**AGENDA
CITY OF KENTWOOD PLANNING COMMISSION
TUESDAY, JUNE 22, 2021
ZOOM MEETING
4900 BRETON AVENUE
7:00 P.M.**

Memorandum

RE: Embassy Park Planned Unit Development

STAFF REPORT: June 14, 2021
PREPARED FOR: Kentwood Planning Commission
PREPARED BY: Lisa Golder
CASE NO.: 18-21 Cobblestone 3

01 ARCHITECTURAL SITE PLAN
AS-1 1" = 30'

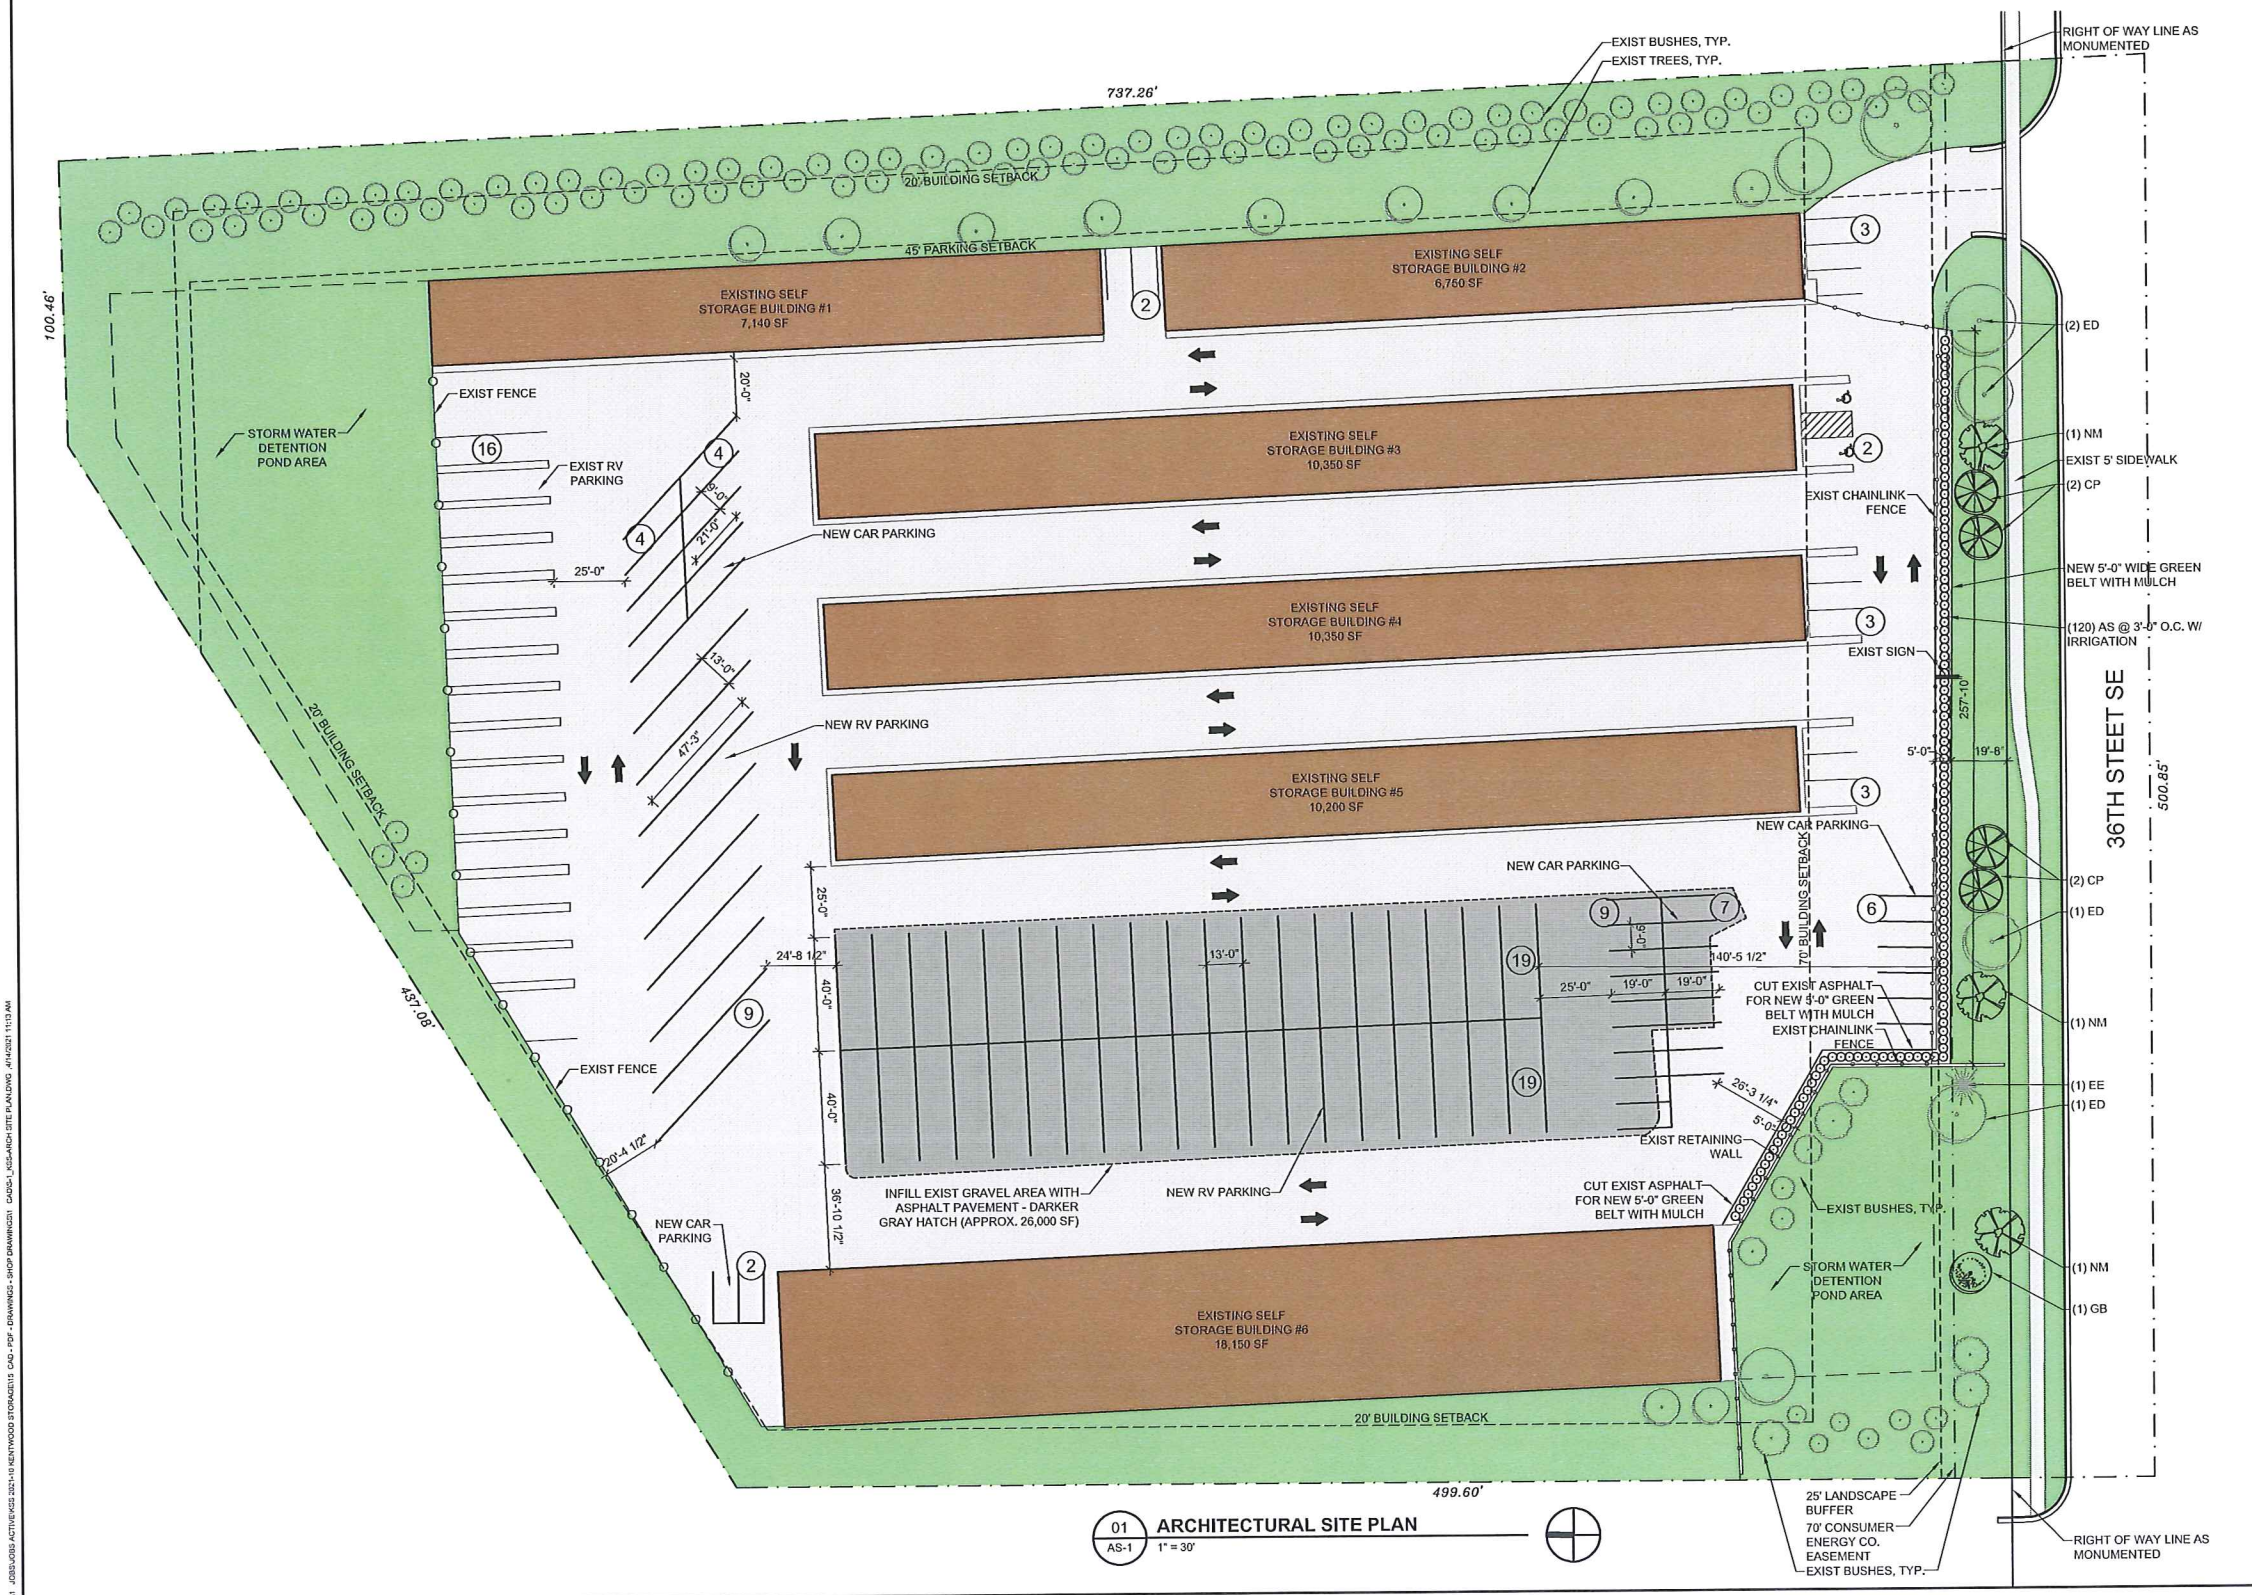
- 1) The drawing named "2021-04-14_KSS-ARCH SITE PLAN-meets car req.pdf" shows a site plan sketch with car parking stalls meeting the zoning requirements.
- 2) The drawing named "2021-04-14_KSS-ARCH SITE PLAN-less cars.pdf" shows a site plan sketch maximizing the RV parking (not meeting the car parking zoning requirements)

Our preference is the "2021-04-14_KSS-ARCH SITE PLAN-less cars.pdf" showing the maximum number of RV parking. This layout has the public views along 36th Street blocked by the existing berm and the new 6' high (min.) vegetation screen.

Based on this provided data, we are asking for a reduction of car parking stall counts in the hope to maximize the real parking needs and not provide for car parking stalls that may not ever be used.

Site Layout Plan

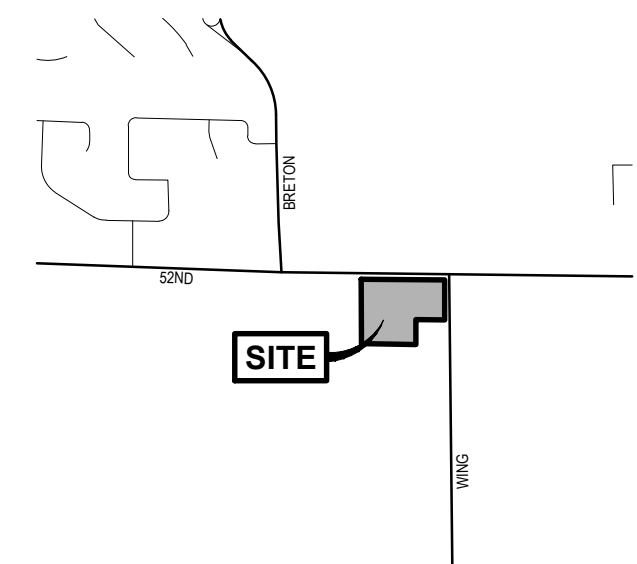
building envelope can accommodate a house construction on lot 1. They are going to work with the City to extend the 3 lane cross section on the pavement that is from Wing Avenue at 52nd Street and carry that across the entire frontage and provide more left turn storage for traffic traveling north on Wing Avenue.

Section 12.04 D 5 indicates that the city may require architectural diversity between adjacent single family buildings. The applicant is proposing 5 different building elevations. The PUD Statement shall include language to indicate how the developer intends to ensure that the same house plan/building elevation is not used for adjacent structures.

Morgan questioned how lot 1 would look compared to the other homes. Cole stated the majority if not all of the houses would be placed right up against the front setback line and the building envelope and on lot 1 that is going to have to be the case with the shape and size there is room for the housing type Workman proposes. Discussion ensued regarding the size of the homes

RECOMMENDATION: Recommend to the City Commission conditional approval of the preliminary site plan dated June 16, 2021 for Lakewood PUD project as described in Case No. 17-21. Application is conditioned on the following:

1. Review and Approval of the PUD Statement dated June 16, 2021 for the Lakewood PUD, and review and approval of the Lakewood PUD Development Agreement by Kentwood staff and the City Attorney. The PUD Statement and Development Agreement shall include, but not be limited to, the following:
 - a. Restrictions prohibiting the rental of more than one unit by a single purchaser.
 - b. A statement regarding the improvements to be undertaken by the developers of the project.
 - c. Detail on sidewalk provided in the development, open space within the development, and the maintenance of these areas.
 - d. Detail regarding any public or private road improvement required for the development.

Case No. 18-21 Major Change-Cobblestone 3

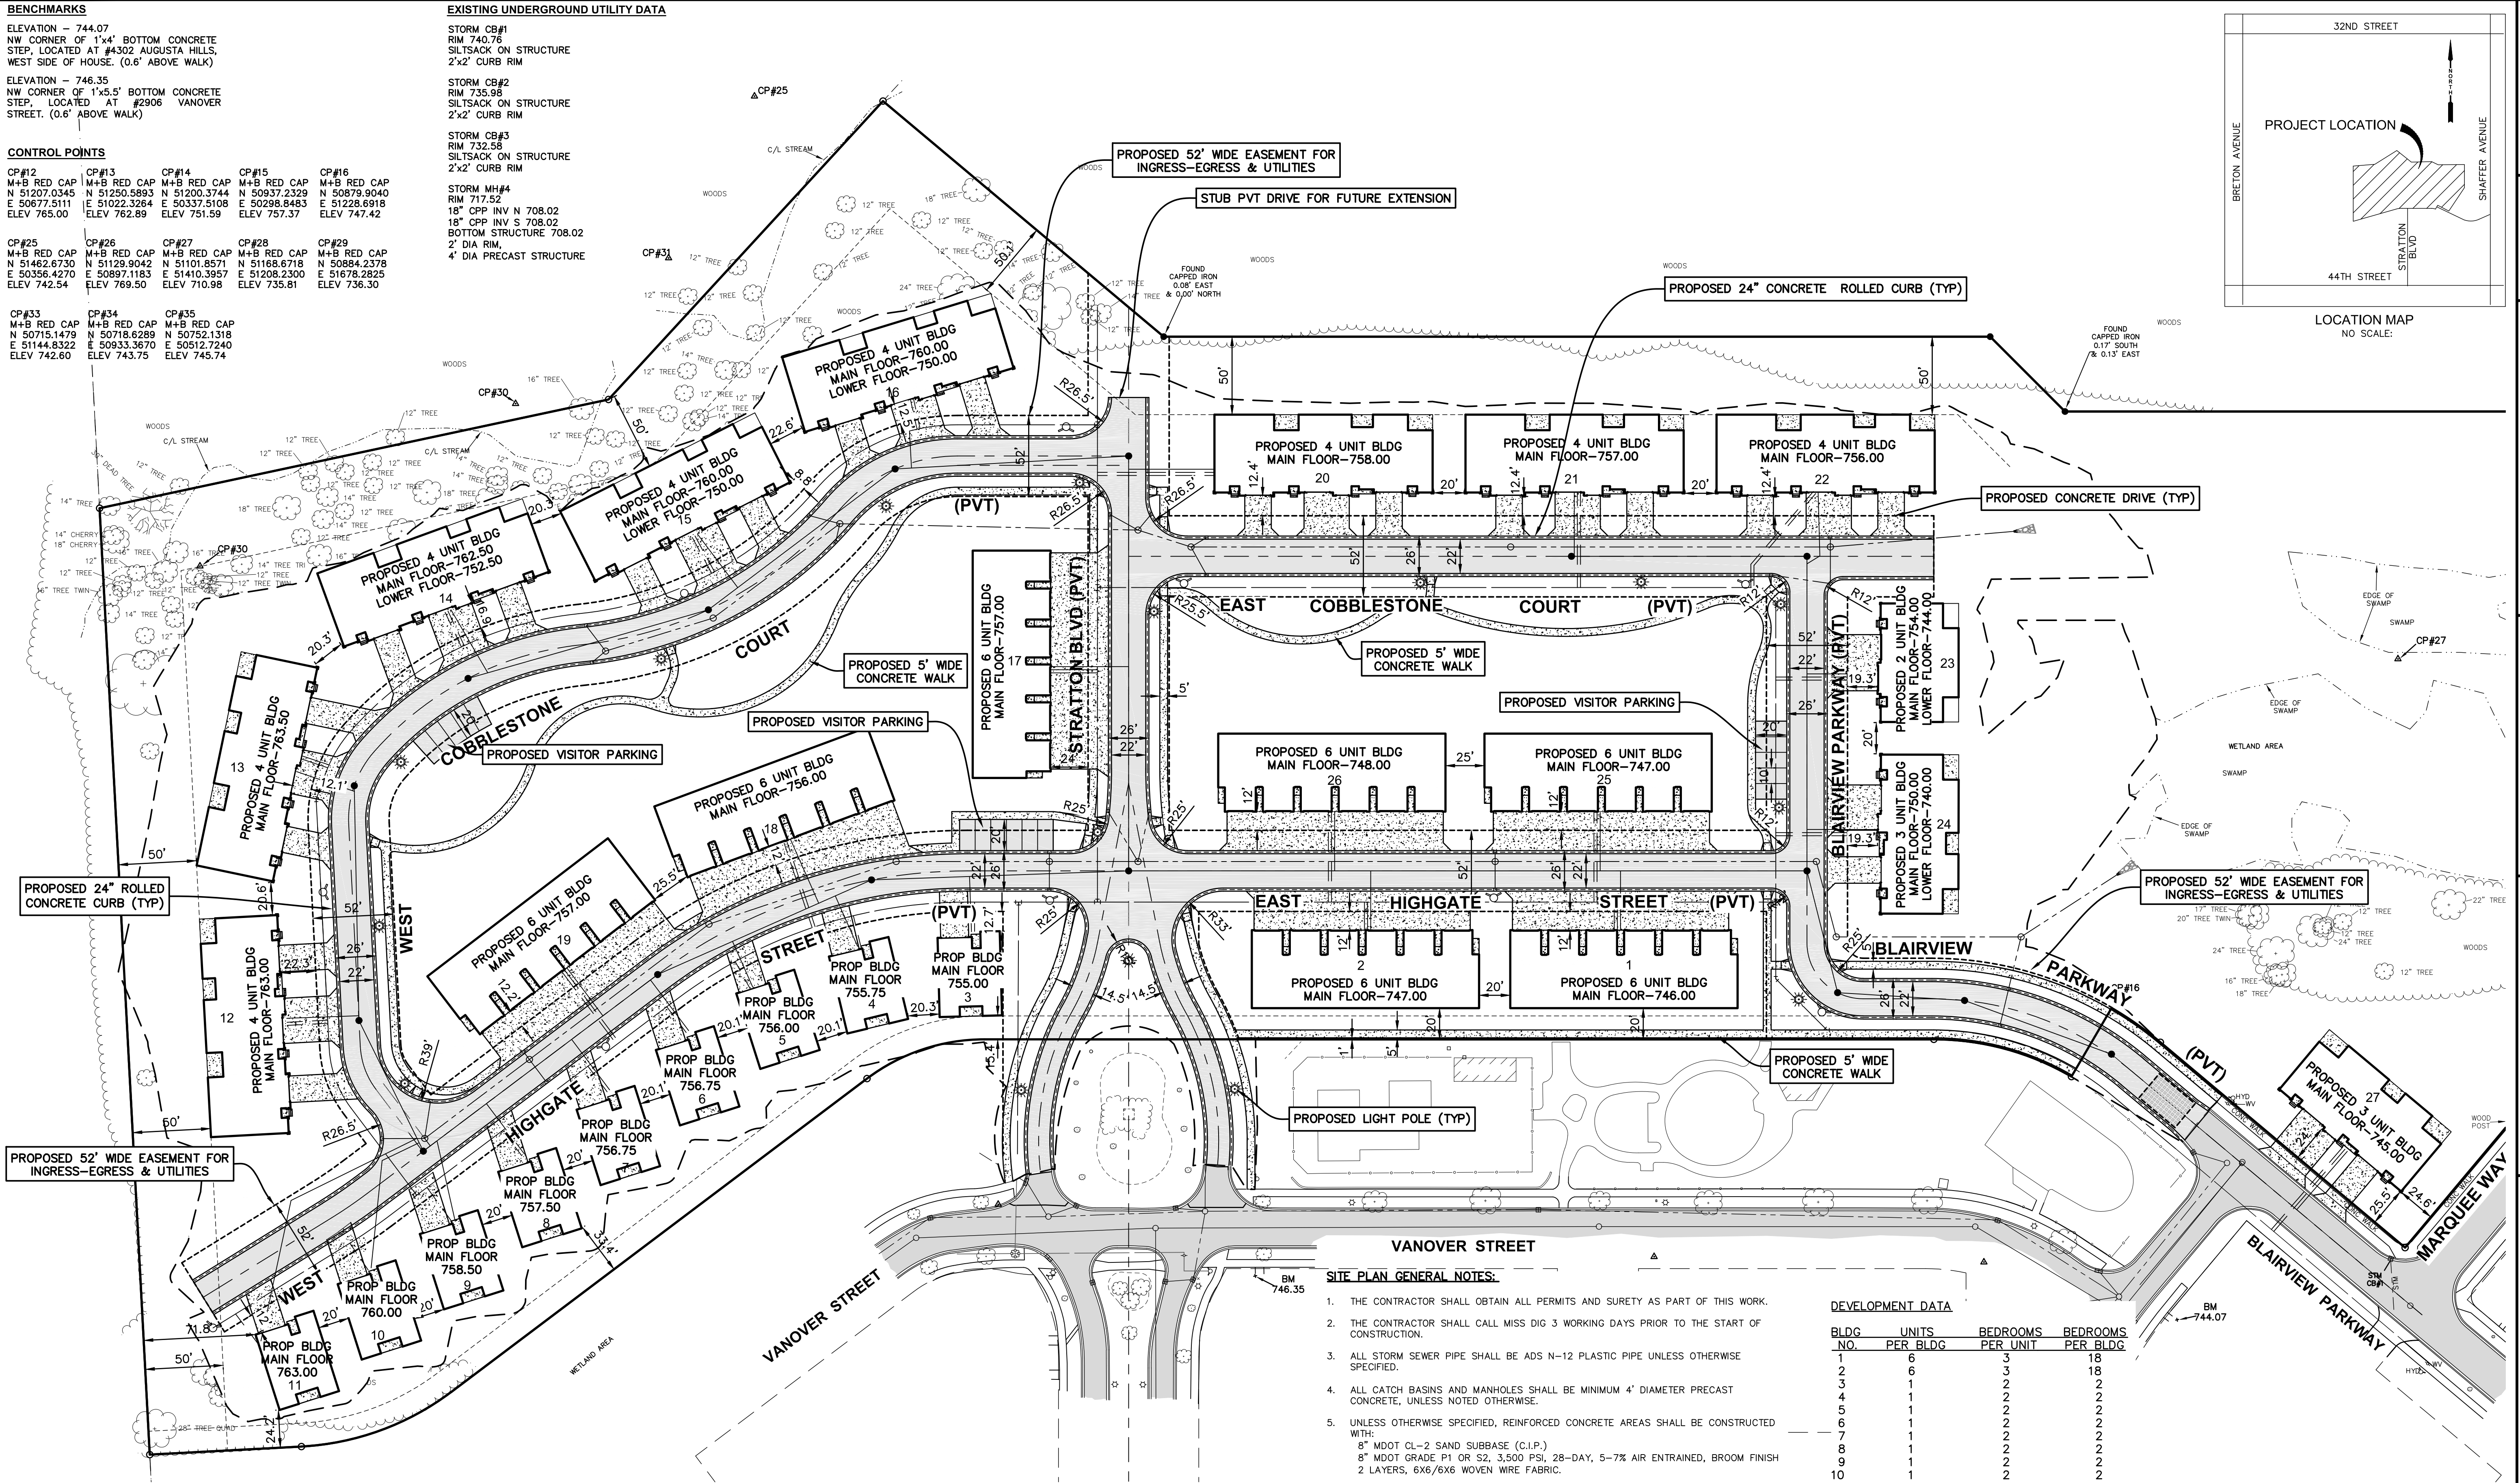
2. The previously approved plan show no units exiting onto Stratton Boulevard; rather, they were served by alleys. The applicant should provide alley access to the 6 unit building. In fact, the original plan showed all but a few of the homes within Phase 3 served from alleys. All of the homes in the proposed Phase 3 are served from the private roads, rather than from alleys. The applicant should describe this change to the nature of the development in Phase 3.

3. The original Ravines PUD promoted pedestrian access, with sidewalk connections on both sides of the street, particularly within the Cobblestone portion of the development. The original plan for Phase 3 provides two side of sidewalk along the private driveways. The proposed plan has sidewalk on only one side of the street in most locations. Staff recommends requiring two sides of sidewalk within the development.
